SAN DIEGO STATE UNIVERSITY MISSION VALLEY CAMPUS MASTER PLAN FINAL ENVIRONMENTAL IMPACT REPORT VOLUME II - RESPONSE TO COMMENTS

January 2020

Figure A

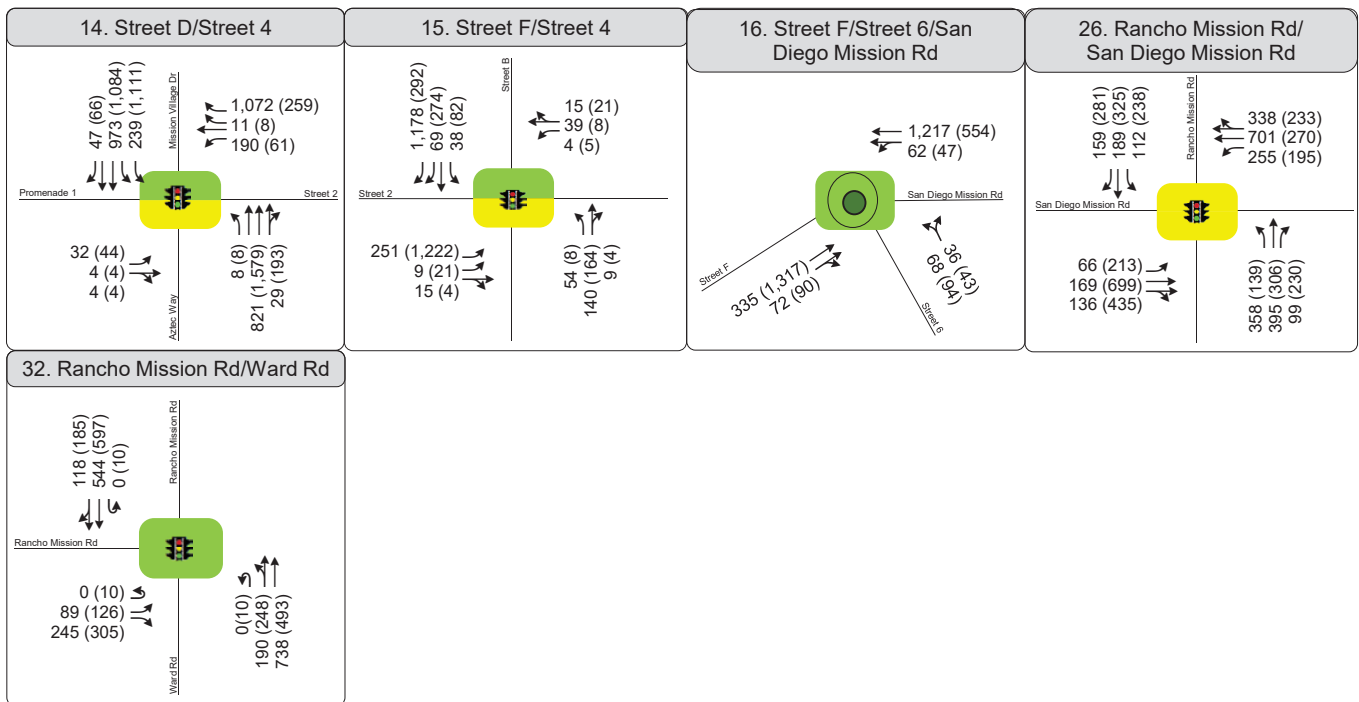
at Ward Road/Rancho Mission Road. The change in trip assignment and the total resulting volumes at the five affected (5) intersections are presented on **Figures A and B**, respectively.

Figure 1

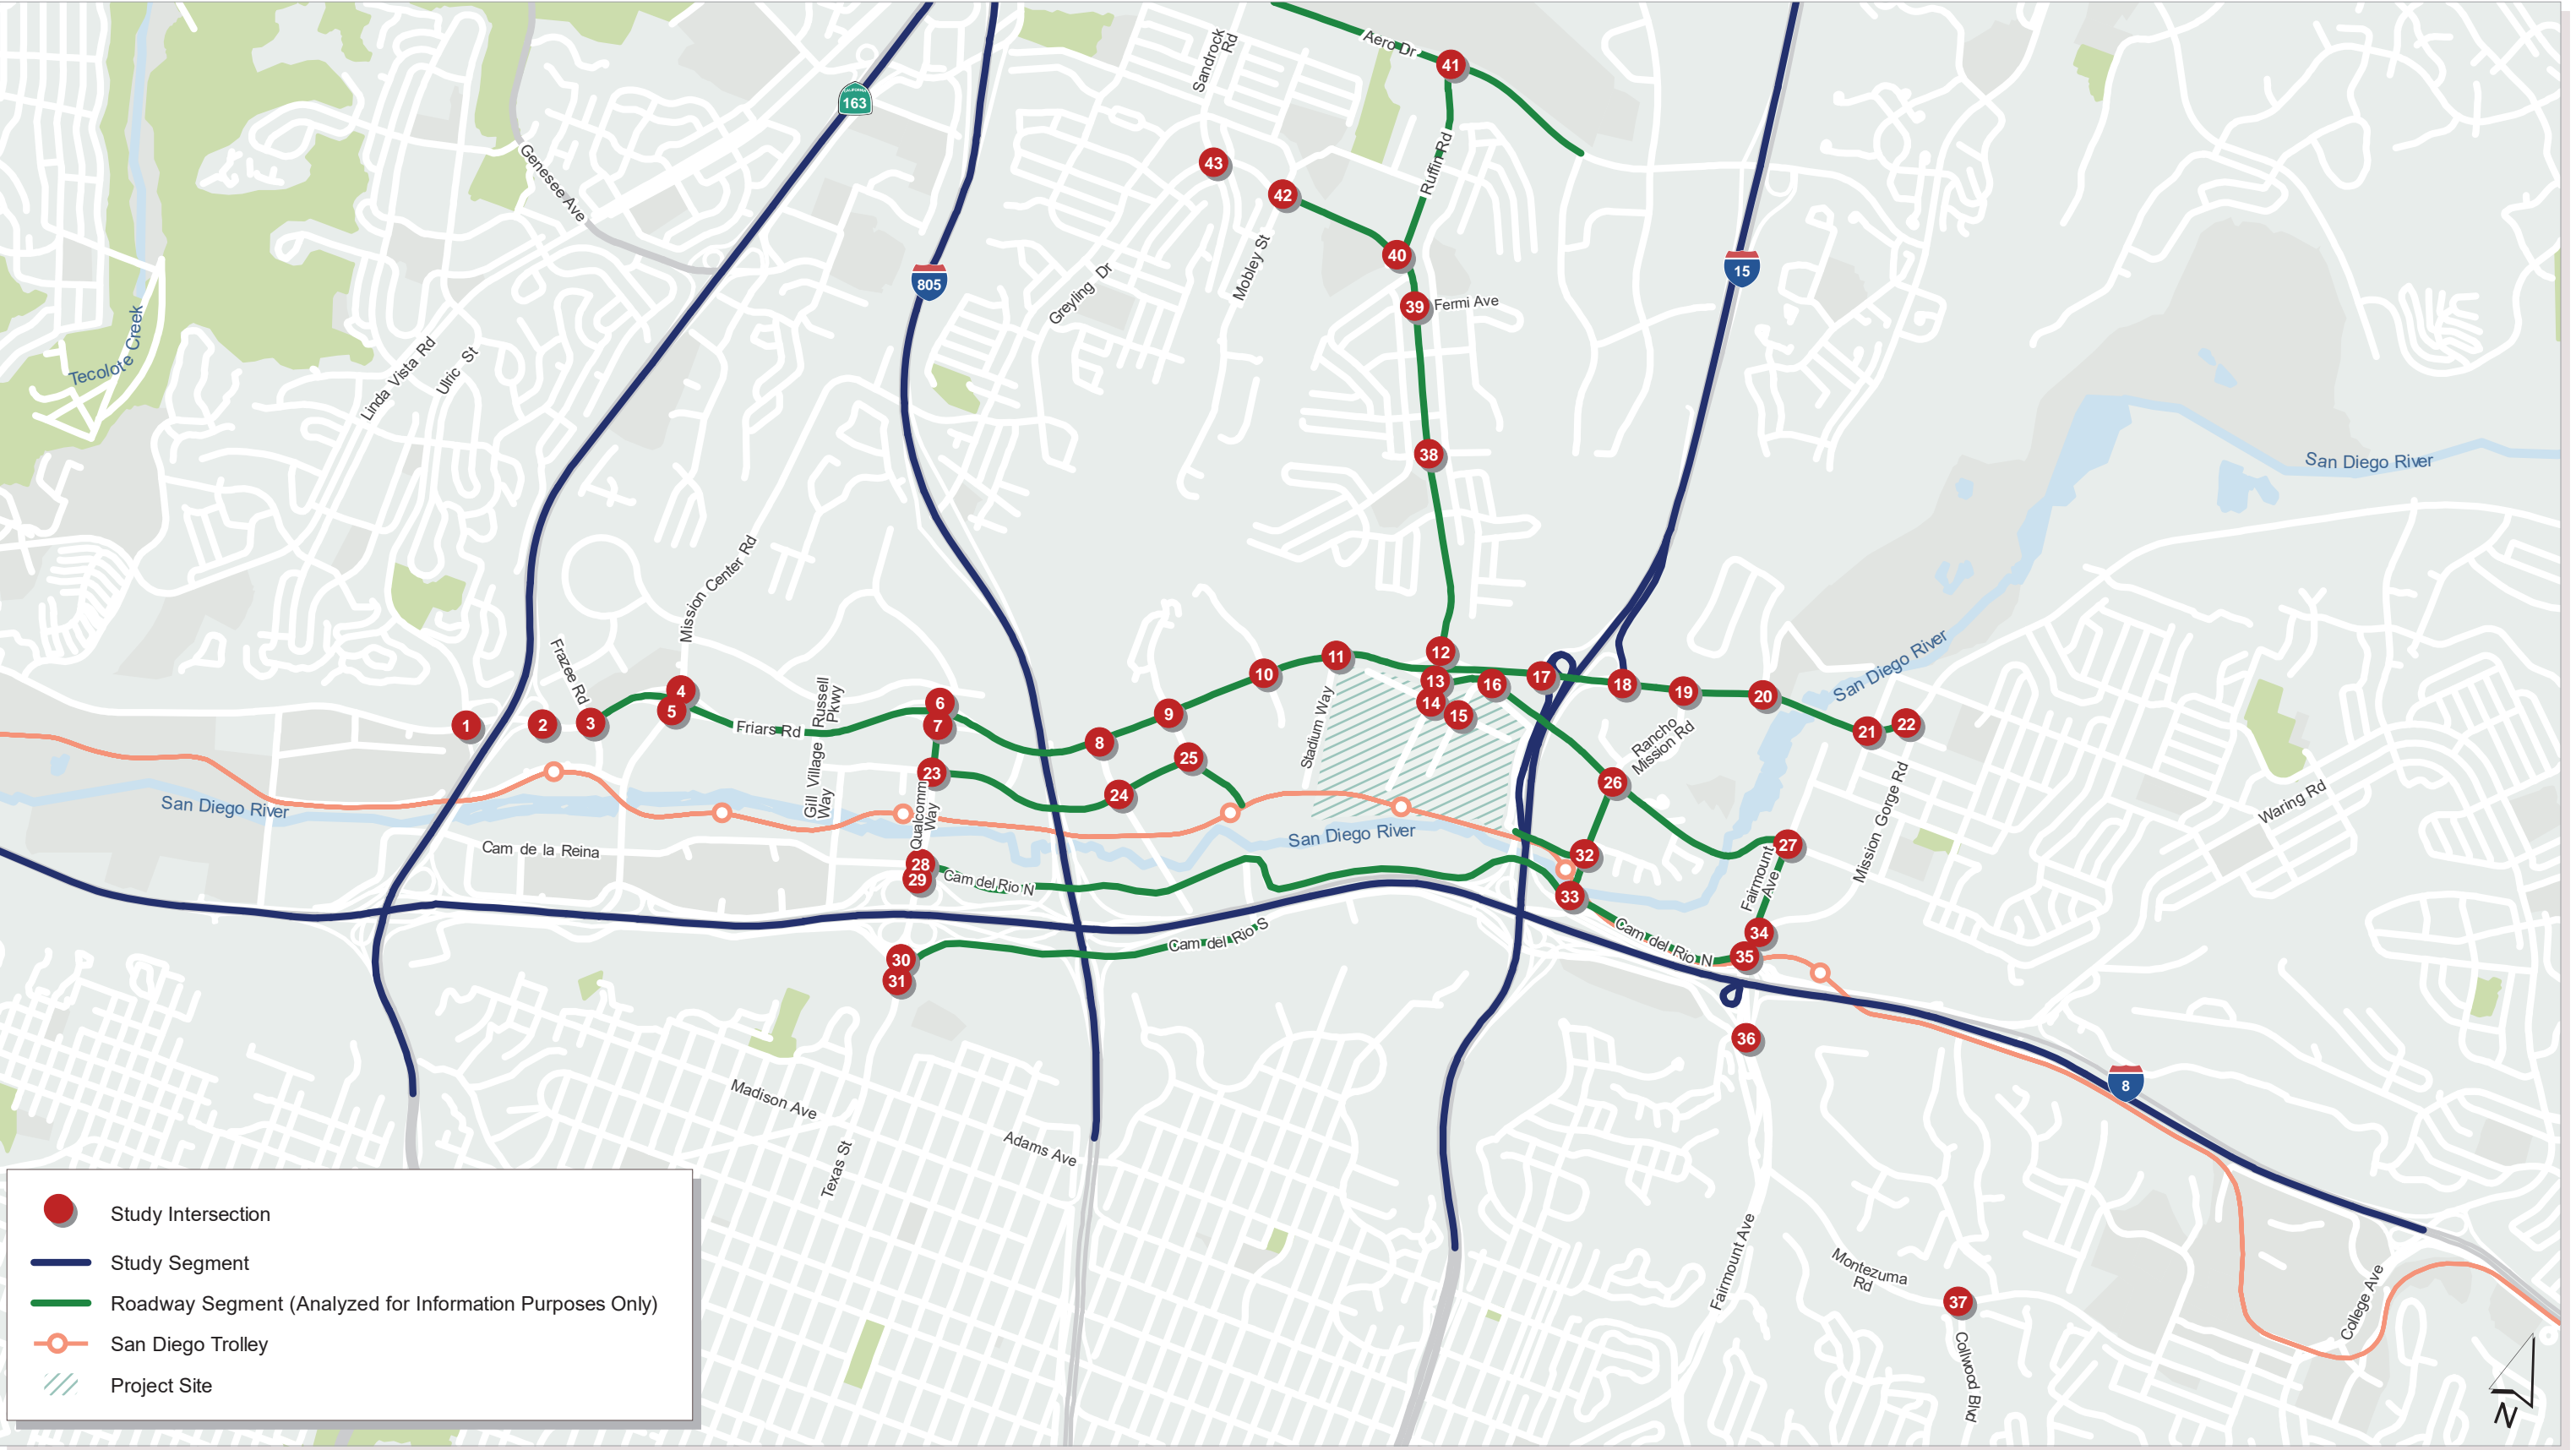
Figure 1 presents the unadjusted Year 2035 select link assignment from the model and illustrates the source of all traffic expected to use the bridge. As can be seen on the figure, besides the project traffic analysis zone (TAZ) depicted by the link with 4,871.02 daily trips, additional sources of bridge traffic include development on Friars Road to the east and west, Fenton Marketplace, Mission Village Drive, Rio San Diego Drive, Camino del Rio North and South, as well as areas served by Texas Street, I-15, and Fairmount Avenue/Montezuma Road.

Accordingly, to properly account for these anomalies, we performed a manual reassignment of Year 2037 volumes to more reasonably estimate local travel paths and the resulting volumes (including those from the project site) that would use the bridge. As shown on Figure 2, 3,461 project trips are forecast to use the new 2-lane bridge on a daily basis out of a total of 14,194 total daily trips based on this reassignment. Using these numbers, the project’s share of total daily traffic at project buildout on the new 2-lane bridge would be 24.4% ($3,461/14,194 = 24.4\%$).

Figure 4.9-5
Conceptual Bio Retention Basin

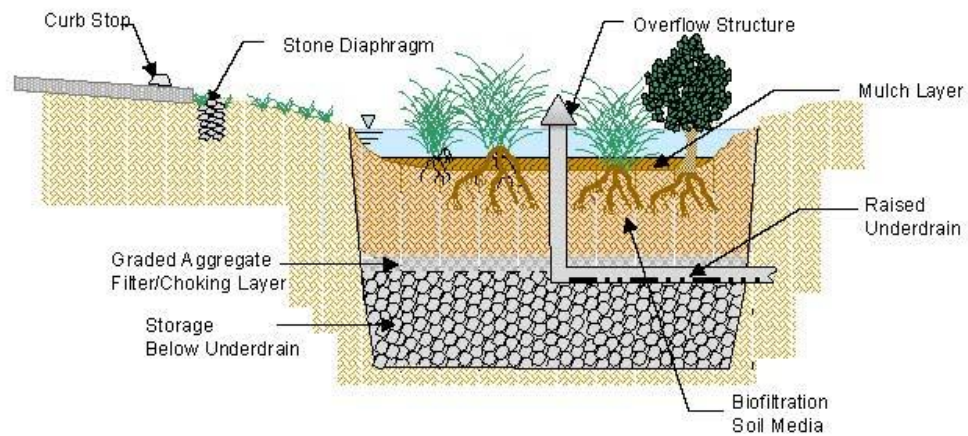
Draft EIR Figure 4.9-5, reproduced below, provides a conceptual illustration of a bioretention basin. In addition to the bioretention basins, lined biofiltration planter boxes would be used throughout the campus (see Draft EIR Figure 4.9-6, Conceptual Biofiltration Planter Box). These biofiltration BMPs achieve water quality treatment by filtering captured stormwater through vegetation and layers of treatment media and drainage rock prior to controlled releases through an underdrain and surface outlet structure (Draft EIR Section 4.9, Hydrology and Water Quality, p. 4.9-22). These biofiltration BMPs also reduce flows to natural channels through infiltration (where feasible) and evapotranspiration (which is the process by which water is transferred from the land to the atmosphere by evaporation from the soil and other surfaces and by transpiration from plants) (Draft EIR Appendix 4.9-1, Water Quality Technical Report, Table 5-3, Small MS4 Permit and Corresponding Project Site Design Measures).
